PLANNING & ZONING CASE NO. SP2020-022

08/20/2020: SP2020-022: Comments for Site Plan for 1505 Airport Road

I.1 This is a request for the approval of a Site Plan for an office building on a 0.47-acre parcel of land identified as Lot 5, Block A, Landing Point Addition, City of Rockwall, Rockwall County, Texas, zoned Commercial (C) District, addressed as 1505 Airport Road.

DRAWING NAME:
SITE PLAN

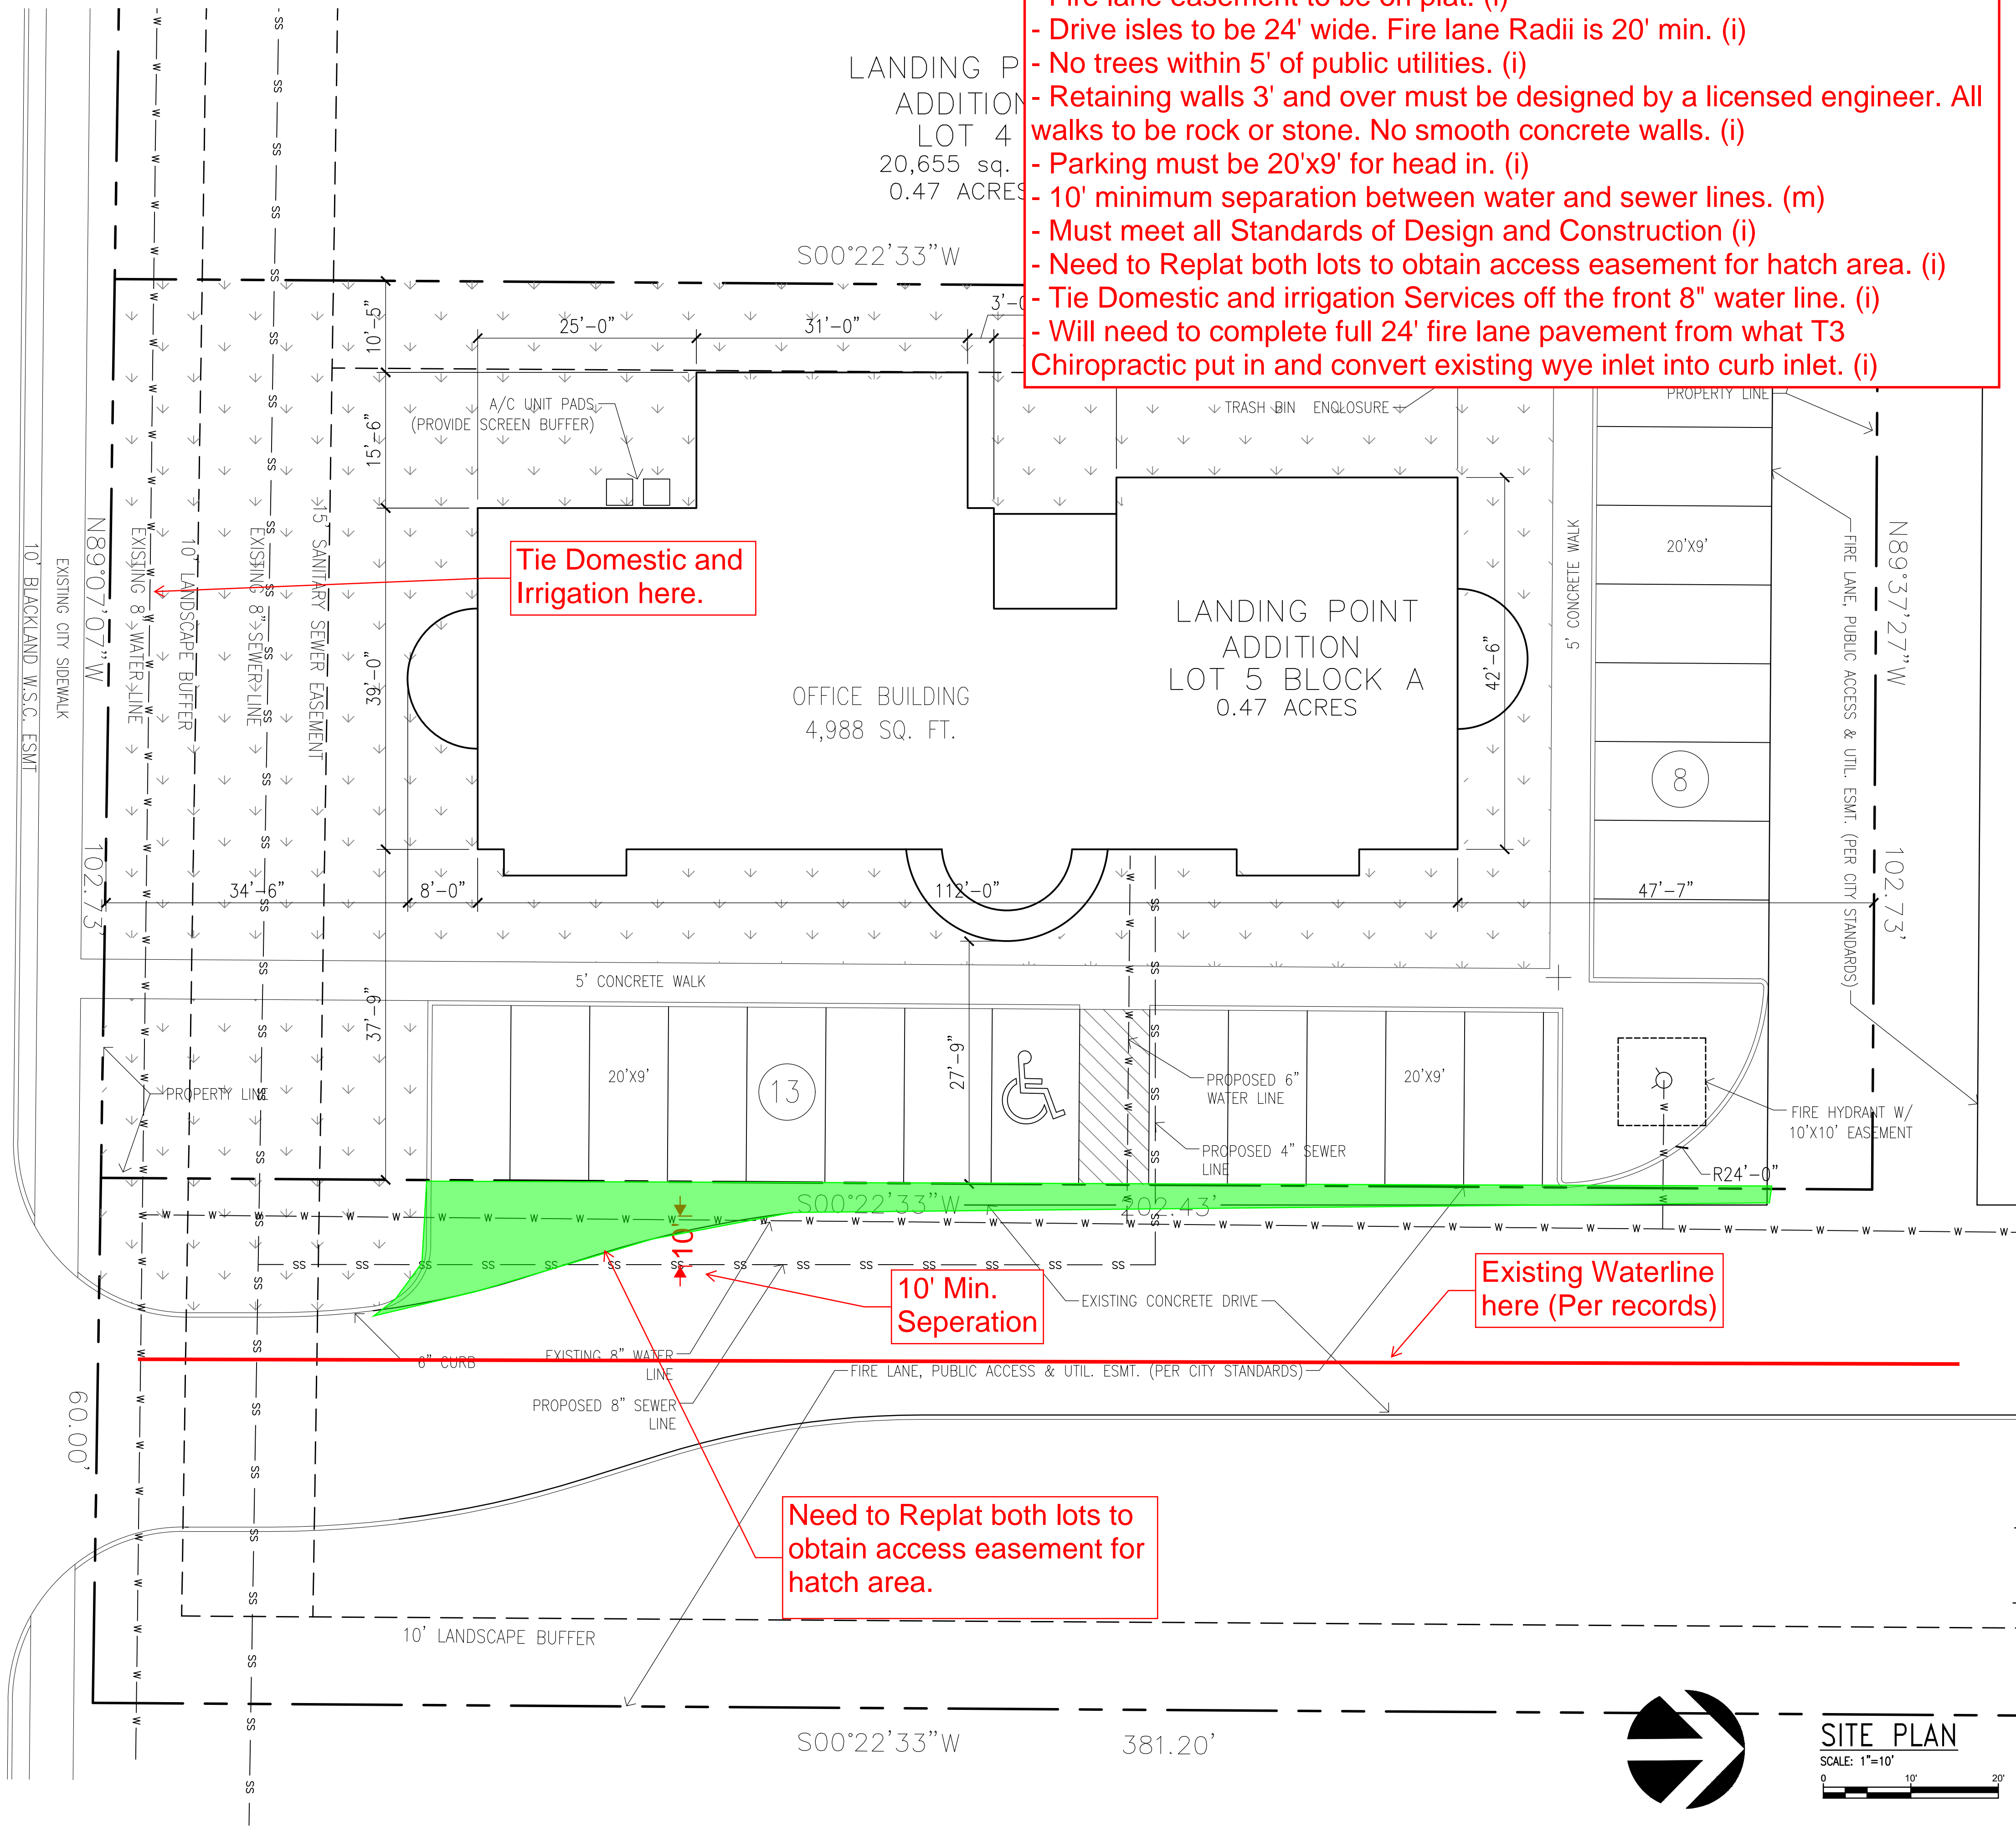
- Engineering review fees apply (i)
- 4% Engineering inspection fees (i)
- Impact fees (Water, Wastewater and Roadway) (i)
- Min 20' utility easements. (i)

- 10' minimum separation between water and sewer lines. (m)
- Must meet all Standards of Design and Construction (i)
- Need to Replat both lots to obtain access easement for hatch area. (i)

- Tie Domestic and irrigation Services off the front 8" water line. (i)
- Will need to complete full 24' fire lane pavement from what T3 Chiropractic put in and convert existing wye inlet into curb inlet. (i)

LANDSCAPE PLAN

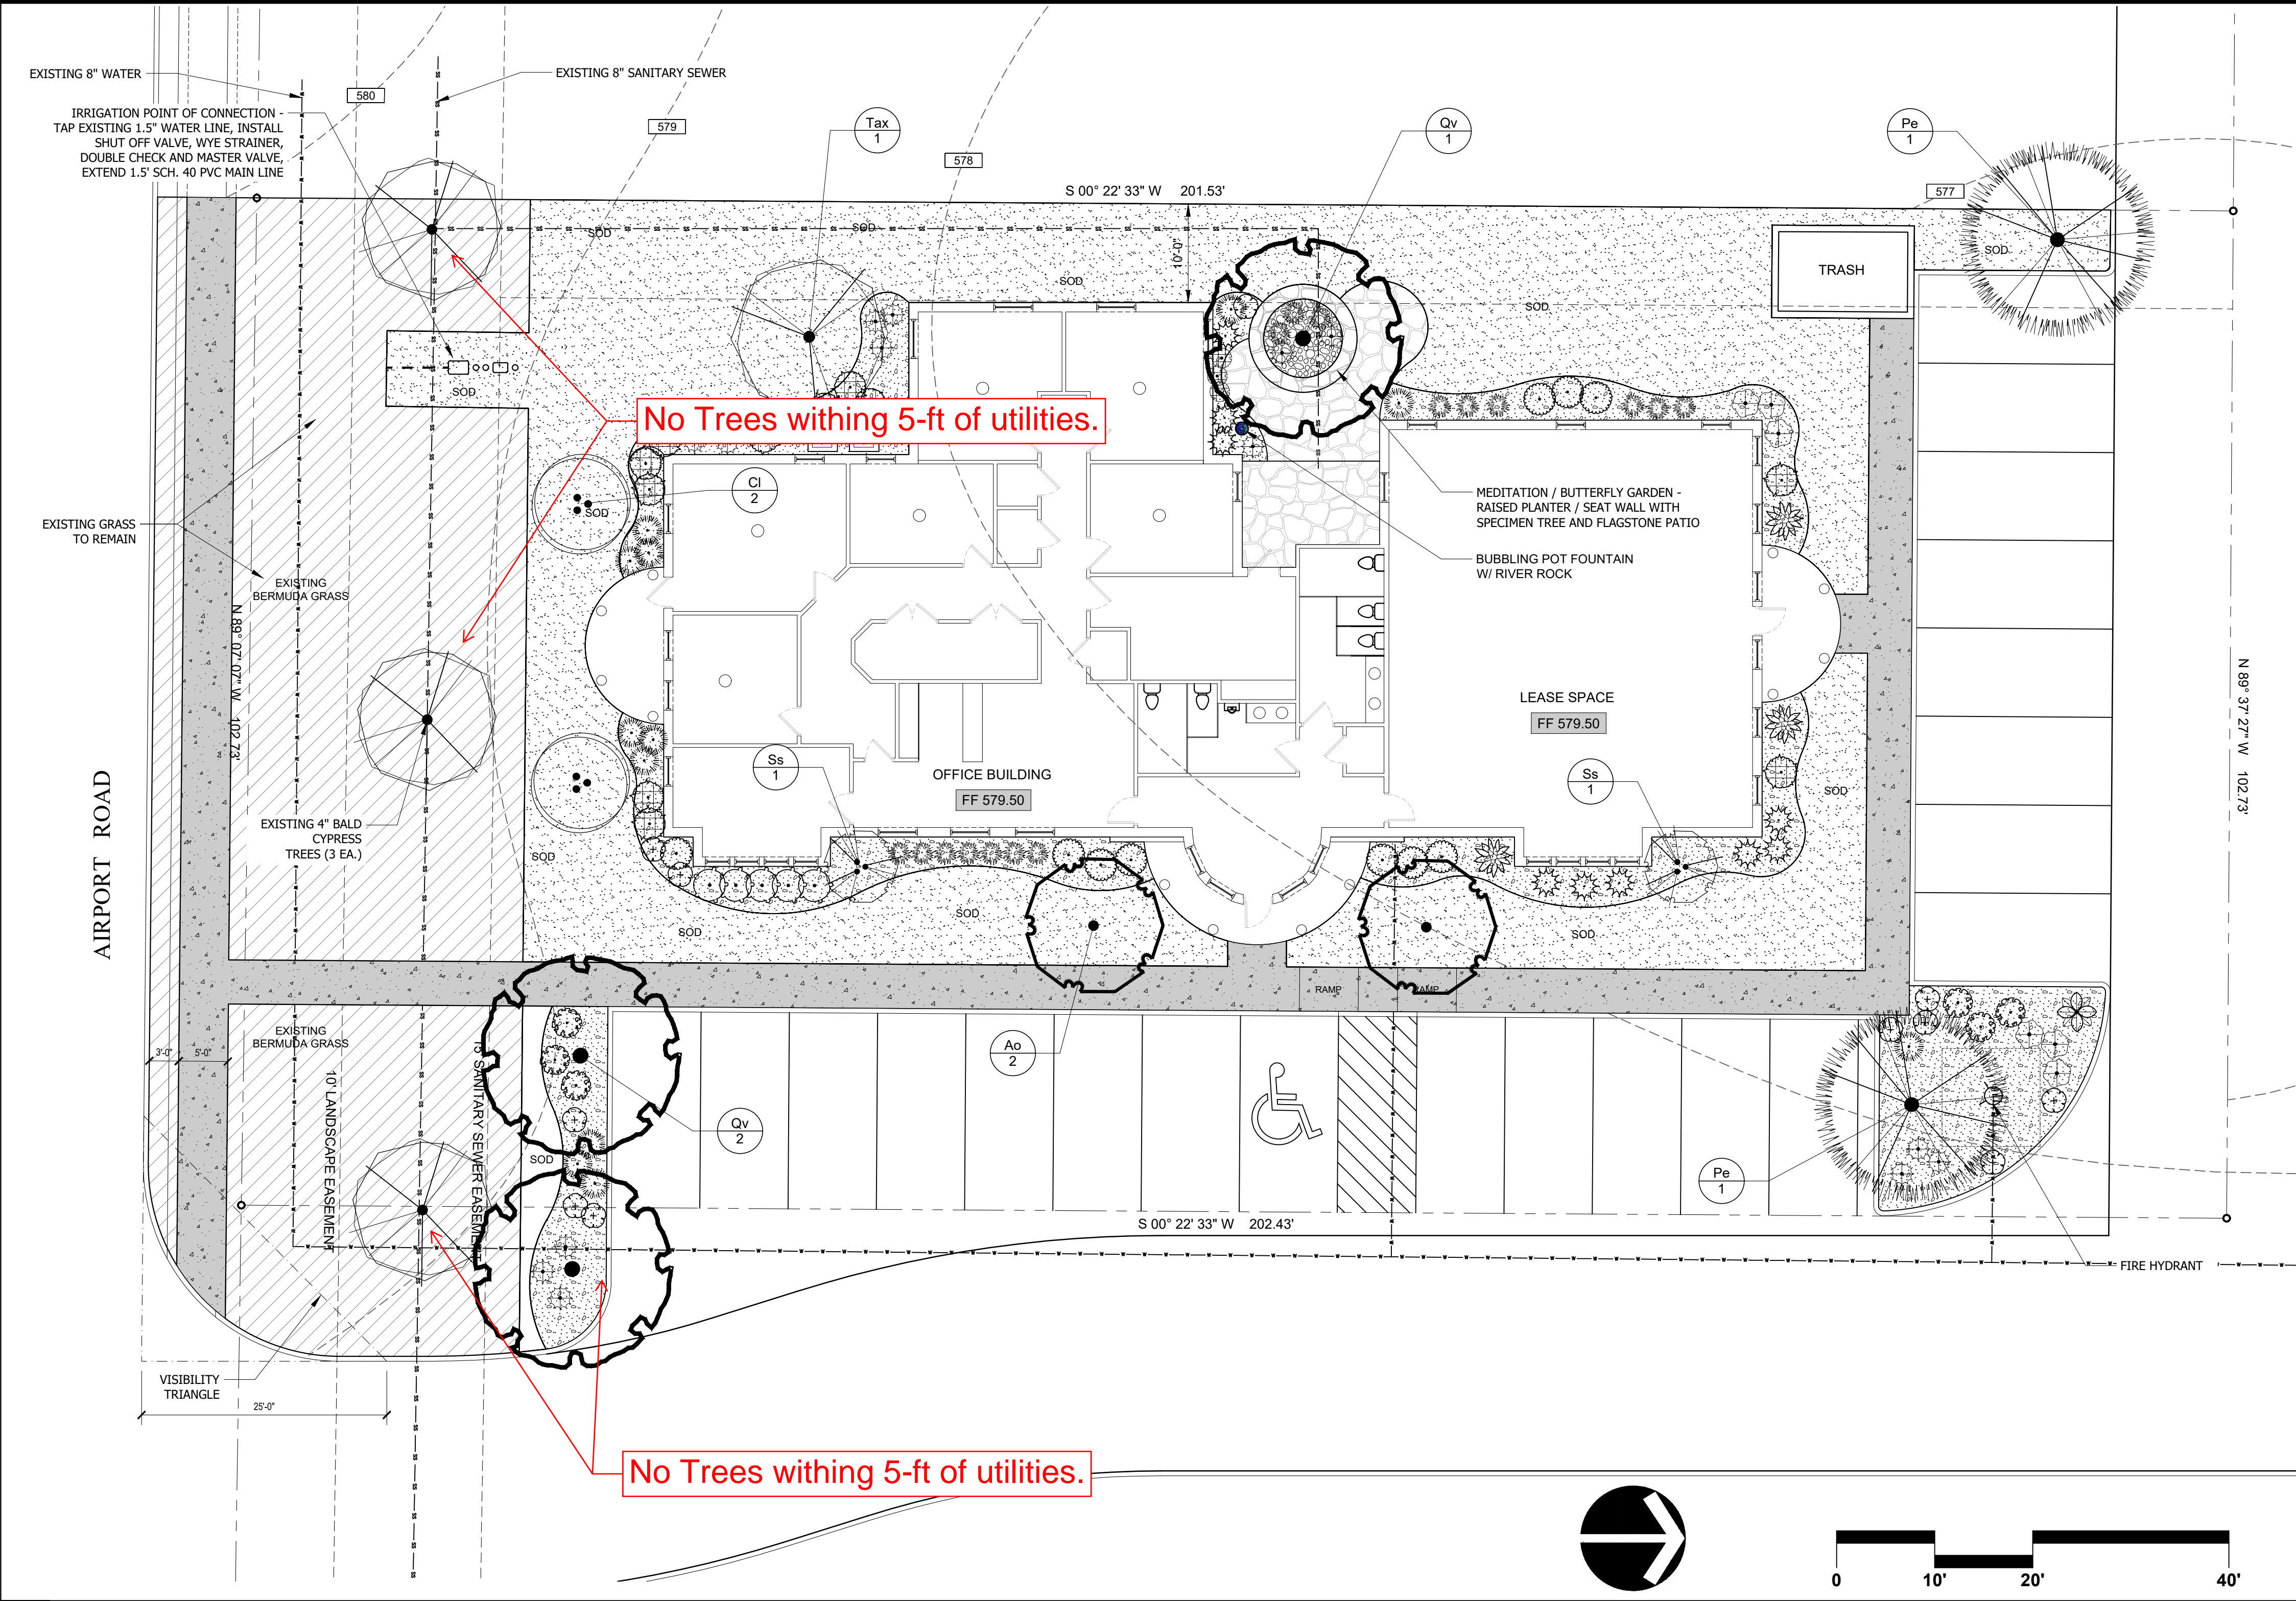
08/17/2020: 1. Please provide Tree Mitigation Plan for existing trees on site

2. *recommendation only: wrap the Glory Burst Maples trunks from ground to canopy for first year to prevent sun scald which can kill the tree.
